**REVIEW OF THE DOE REPORT: "THE ORIGIN OF CALCITE-
SILICA DEPOSITS AT TRENCH 14 AND BUSTED BUTTE AND
METHODOLOGIES USED TO DETERMINE THEIR ORIGIN"**

**SPECIAL REPORT No.18
CONTRACT No. 94/96.0003**

**SPECIAL REPORT Submitted to the
Nuclear Waste Project Office
State of Nevada**

November, 1994

Figure 12 - Summary on Sr-isotopy at Yucca Mountain (data from Hill et al., 1994 and Hill and Schluter, 1994). Circles represent individual data points beyond the $\pm 2\sigma$ interval of data distribution.

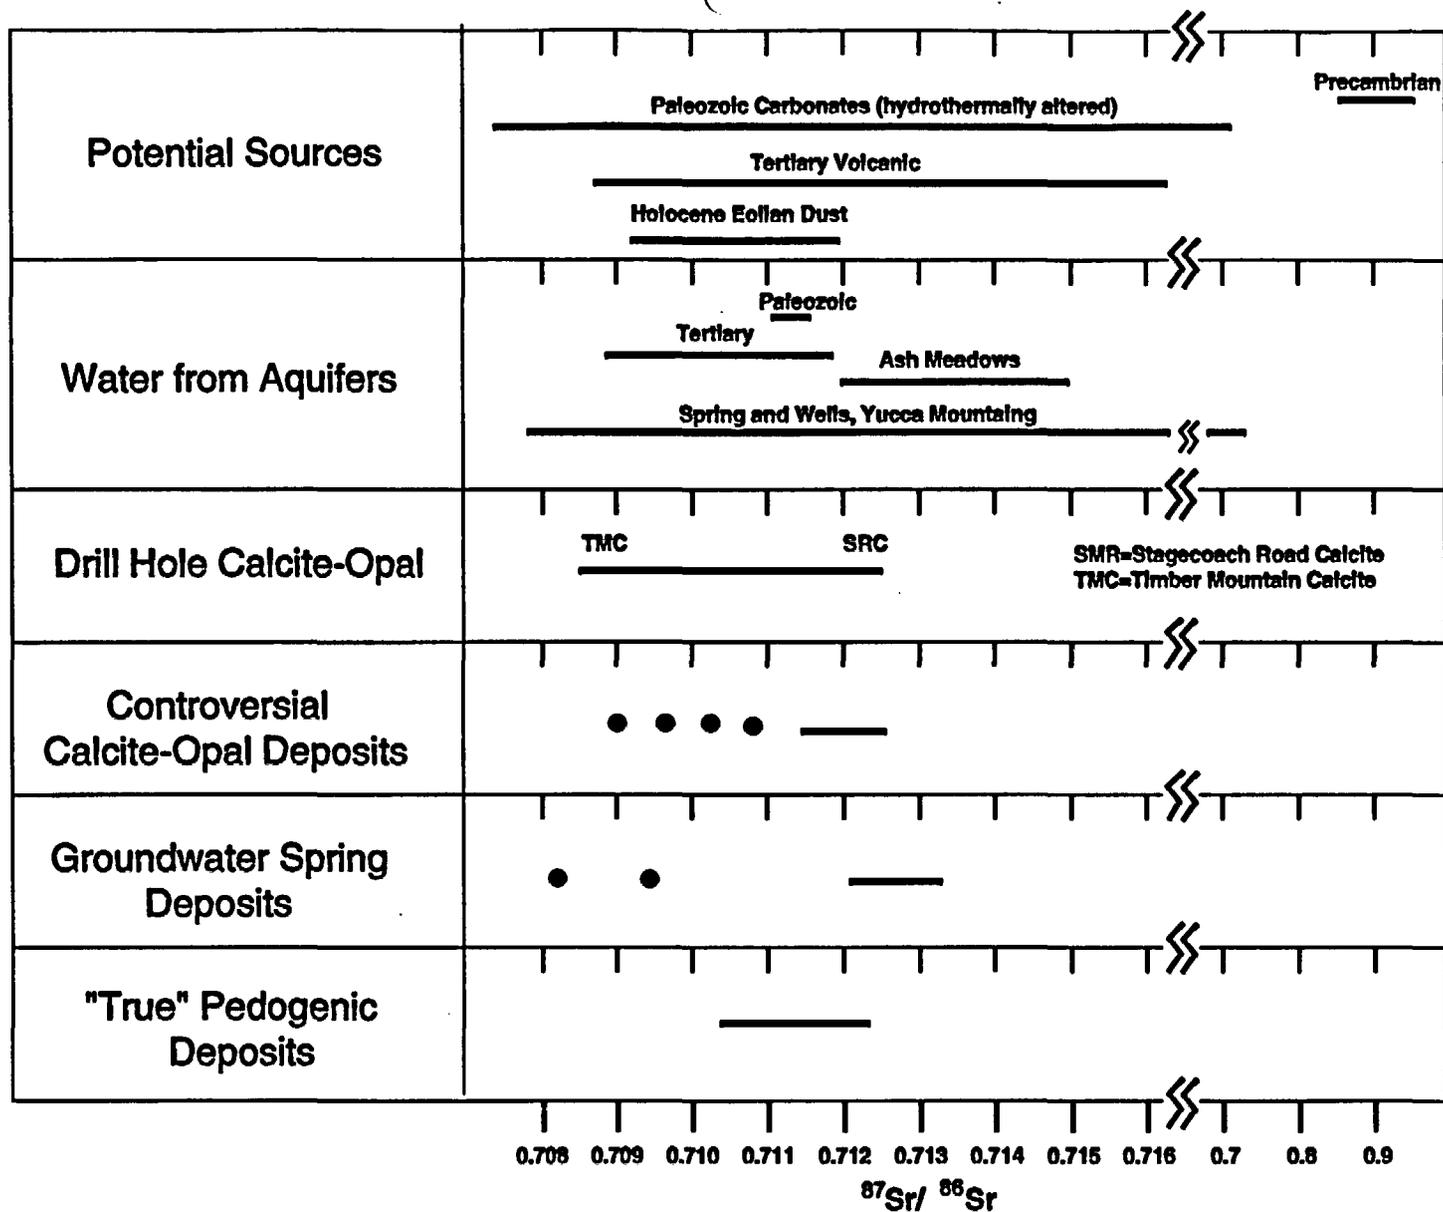
2. Generally speaking, both the advocates of pedogenic origin of the Yucca Mountain controversial deposits (DOE position) and the opponents of this point of view agreed that the altered Paleozoic carbonates and the underlying Precambrian rocks of the area have served as an ultimate source of calcite and strontium incorporated in the controversial Trench 14 and Busted Butte deposits. However, even in the case of a deposit for which the source of incorporated calcium and strontium is beyond dispute,

Figure 1. Fission track ages of zircons from breccias at Busted Butte (top) and Trench #14 (bottom). From Levy and Naeser, 1991.

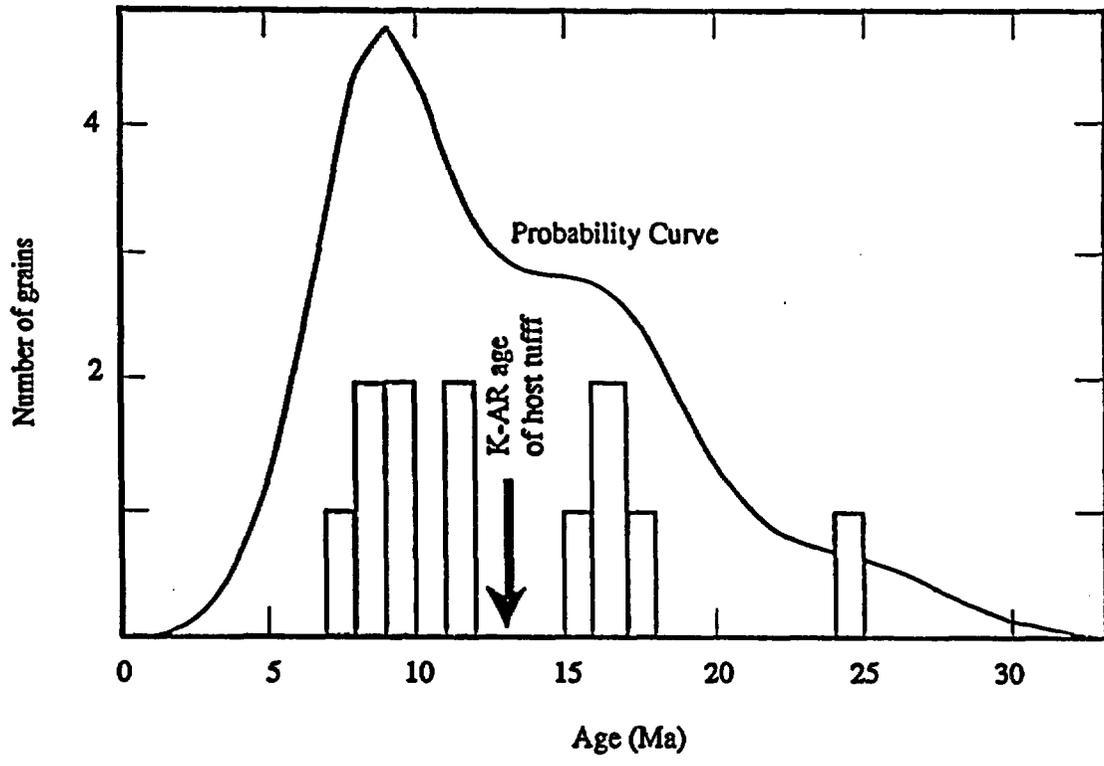
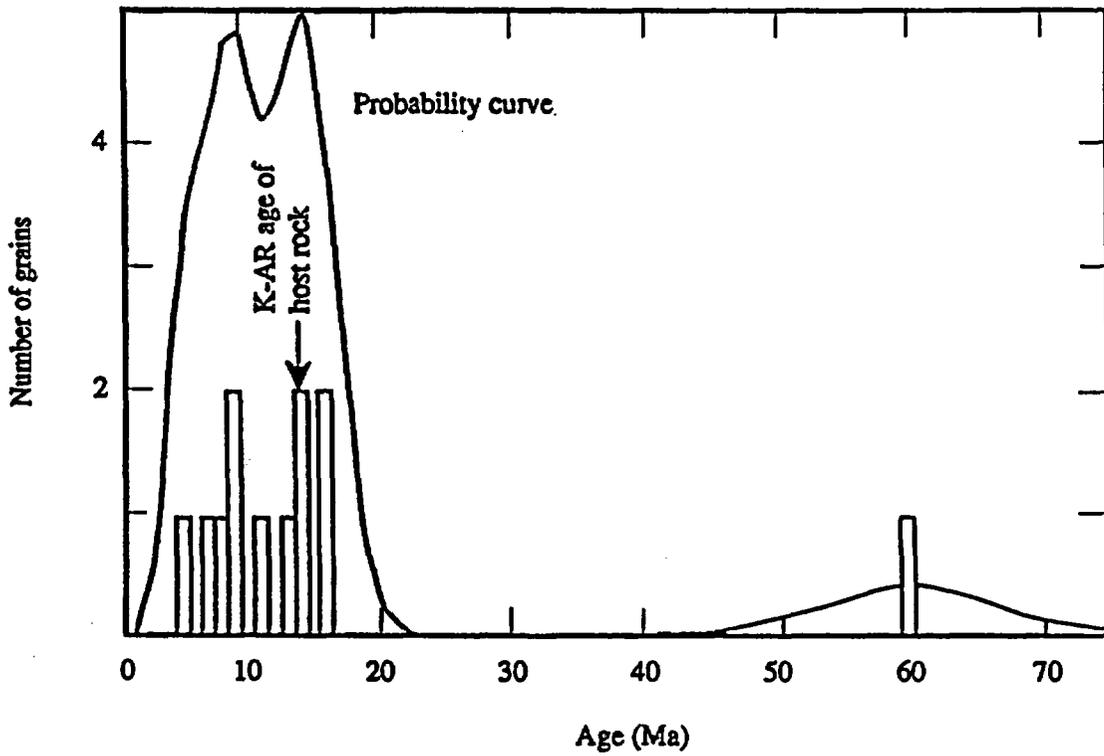
The data shown by Levy and Naeser in their Figures 7 and 8 are reproduced in the attached Figure 1. These data clearly show the multiple peaks identified by Levy and Naeser. *Contrary to what is stated by the Panel*, most of the zircon crystals analyzed from each sample show dates considerably less than the Potassium-Argon ages of the host tuff (13 Ma), rather than greater than the age of the tuff. Further, the Panel implies an age for the host tuff of 10-12 Ma, while it is clearly stated to be 13 Ma.

An examination of the age data, as given in Figure 1, shows that there are ages 4.8 Ma, 6.2 Ma, 7.5 Ma, and 7.7 Ma among the crystals in these two samples. There are

several additional dates near 8.5 Ma. The two sigma interval attached to the youngest age, of 4.8 Ma, is 2.5. Thus, there is very high confidence (over 90%) that the age of heating of this crystal was between 2.3 Ma and 7.3 Ma, with the highest probability for a specific age being 4.8 Ma. The same interpretation of confidence intervals applies to the other ages given. Clearly, characterizing these age data as being within the age range 10-12 Ma, given "analytical uncertainty," is incorrect. It is on this inaccurate basis that the Panel states that (p. 3):

Figure 1. Distributions of glass and zeolite relative to the water table. Drill hole locations are illustrated in Figure 2.

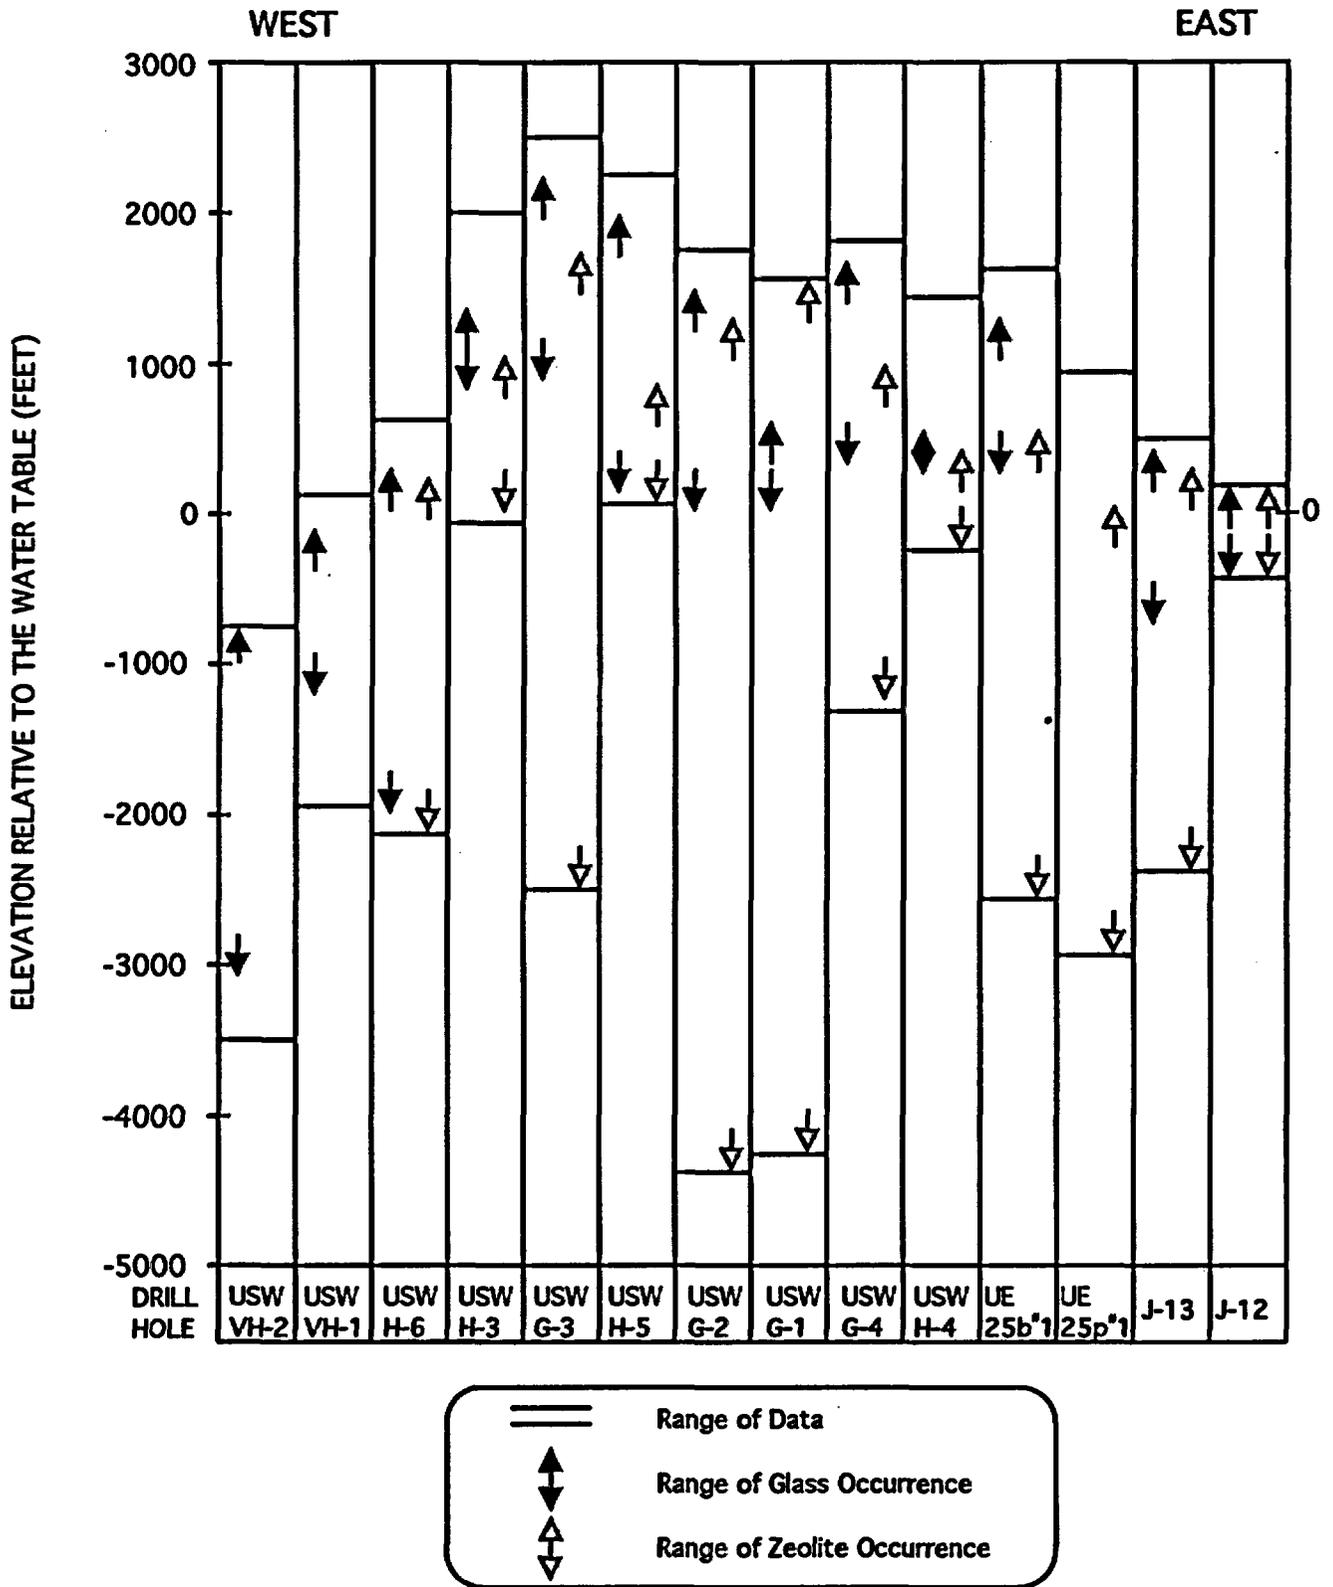
We could not find support for this conclusion from the relevant data (Figure 1). The data show minimum and maximum elevations of the occurrence of glass and zeolites, relative to the water table, as reported by Bish and Chipera (1989), Carlos et al. (1990), Sheppard et al. (1988), Carr (1982), and Carr and Parrish (1985) at the drill sites shown in Figure 2. Levy noted:

Figure 14. Fission track ages of zircons from breccias at Busted Butte (top) and Trench #14 (bottom). From Levy and Naeser, 1991.

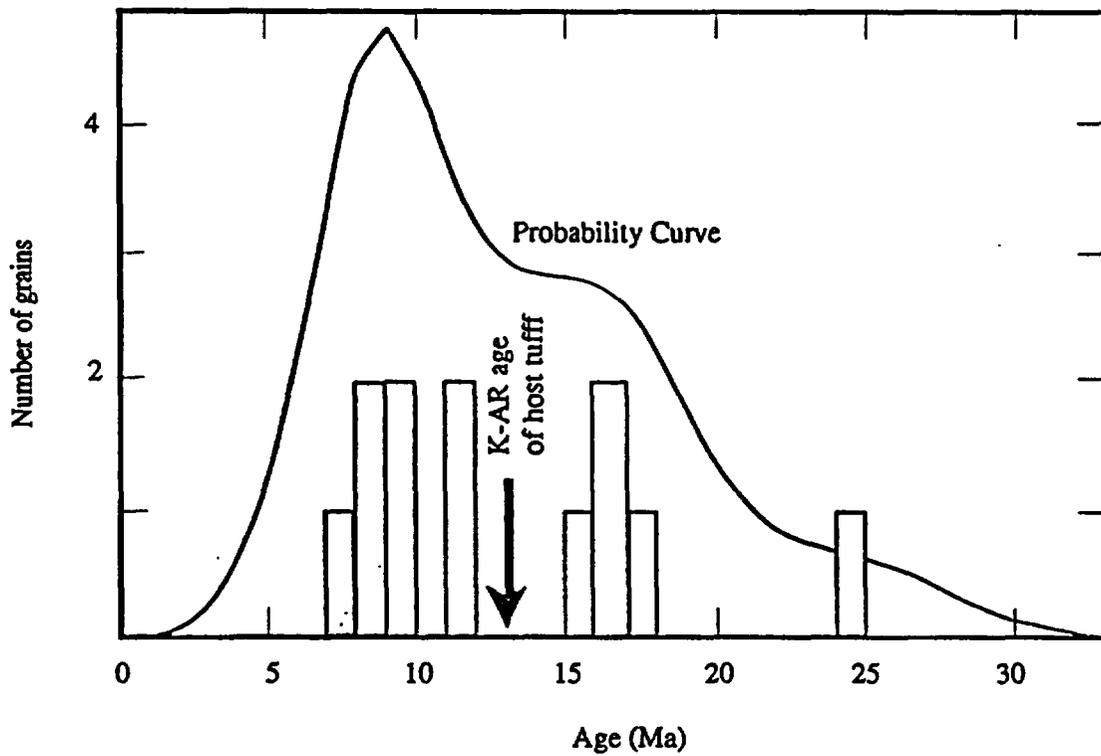
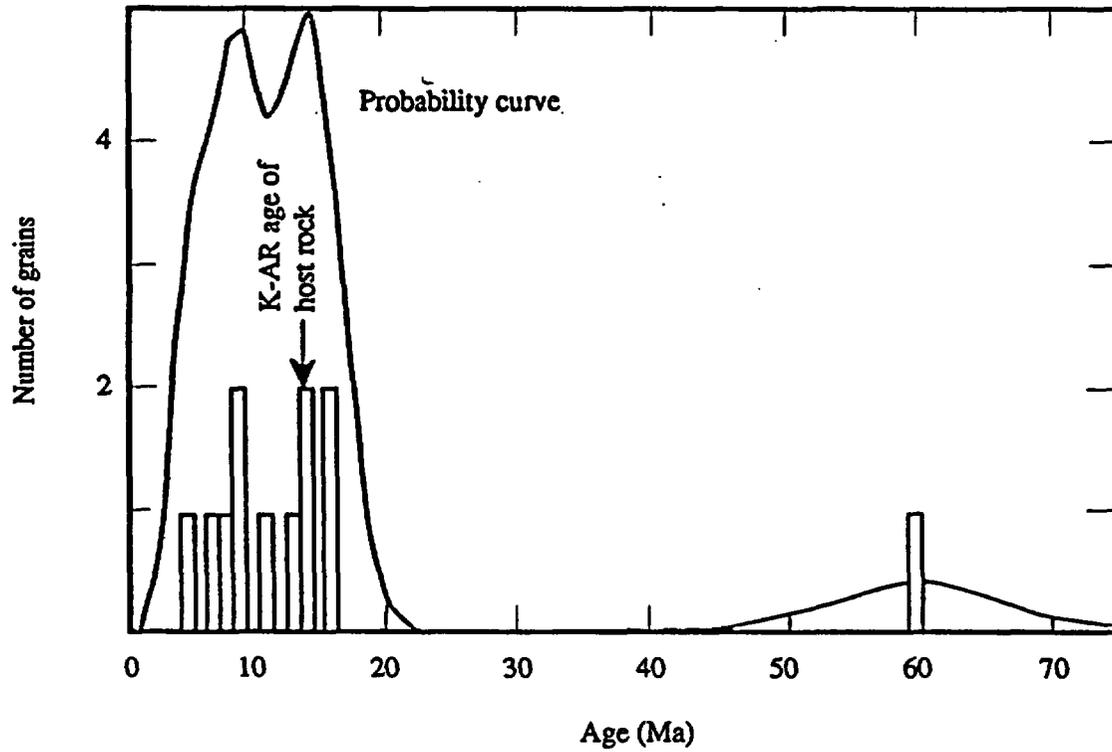
This statement contradicts Levy and Naeser (1991), who attach statistical significance to the multiple age peaks exhibited for both specimens (Figure 14). Furthermore, contrary to the statements by the Panel, the K/Ar age of the host tuff is 13 million years B.P. and not 10-12 million years B.P. as implied by the Panel and secondly, most of the ages from the zircons are significantly younger than the host rock, the youngest being 4.8 million years B.P. Like the younger zircons, the metasomatic zeolites in the vadose zone also carry radiometric ages significantly younger than the age of the host ignimbrites (Figure 4).
